**NUMBER:** 18-101-22 REV. A

**This bulletin supersedes Technical Service Bulletin (TSB) 18-101-22, date of issue May 24, 2022, which should be removed from your files. All revisions are highlighted with **\*\*asterisks\*\*** and includes new Diagnostic Trouble Codes (DTCs), symptoms/conditions, software enhancements and LOP.**

Flash: Powertrain Control Module (PCM) Updates

2019	(DJ)	RAM 2500 Pickup
2019	(D2)	RAM 3500 Pickup

**Fig. 1**  
**CP3.3 Design Pump**

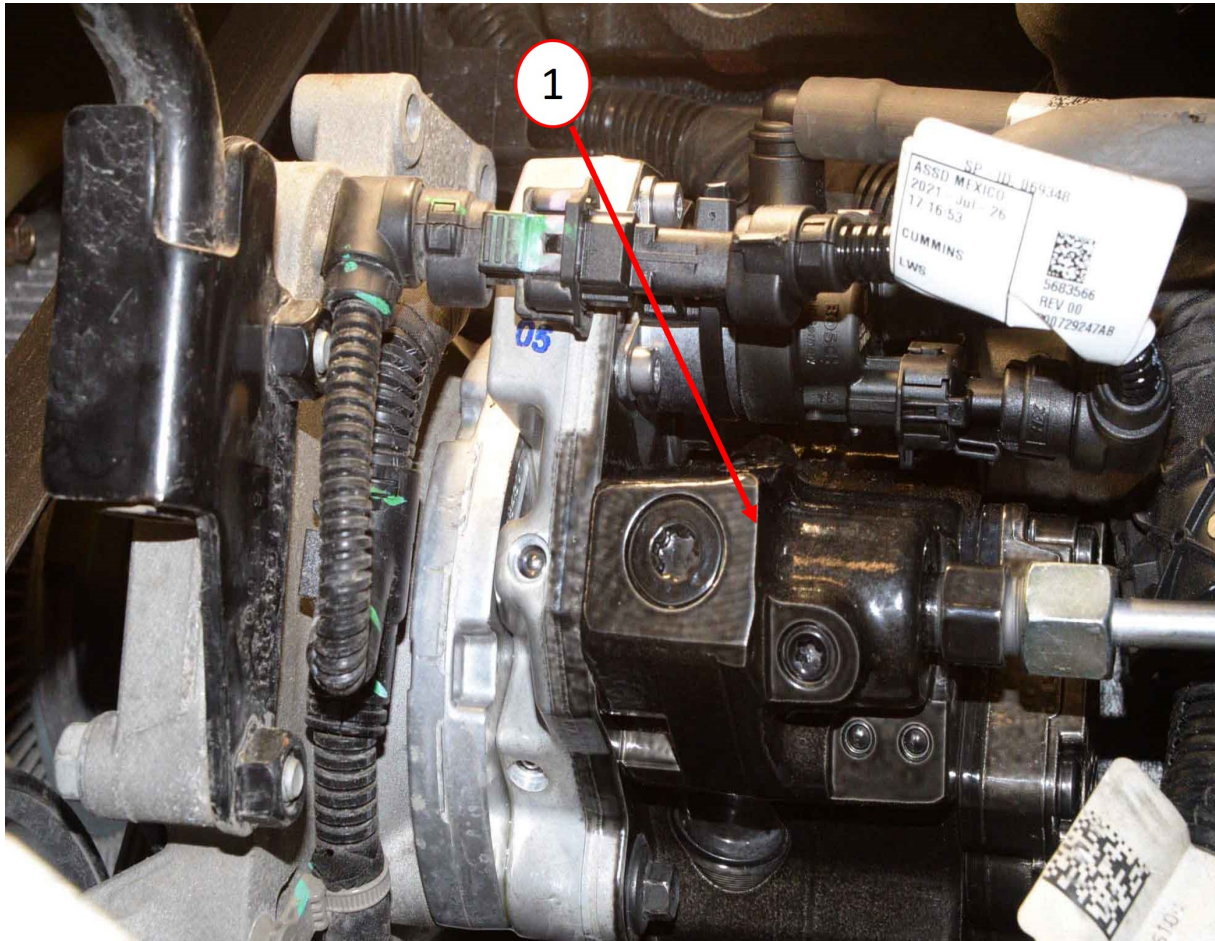
**NOTE:** The only calibration available will be for the updated CP3.3 design High-Pressure Fuel Injection Pump (**Fig. 1**) . Please ensure that recall Y78 has been completed first before proceeding with this update.

1. Inspect the High-Pressure Fuel Injection Pump to see which pump is currently installed on the vehicle (**Fig. 1**) . Also review the vehicle VIP report to see if campaign Y78 has been performed.

2. Does the VIP report indicate that Y78 has been performed, and is the vehicle equipped with the new design fuel injection pump released under the campaign?
  - YES>>> Proceed to [Step 1](#).
  - NO>>> Perform the Y78 campaign first. Once the campaign is performed, new pump installed and PCM updated, the PCM will have all of the updates listed in this document. This Bulletin does not apply.
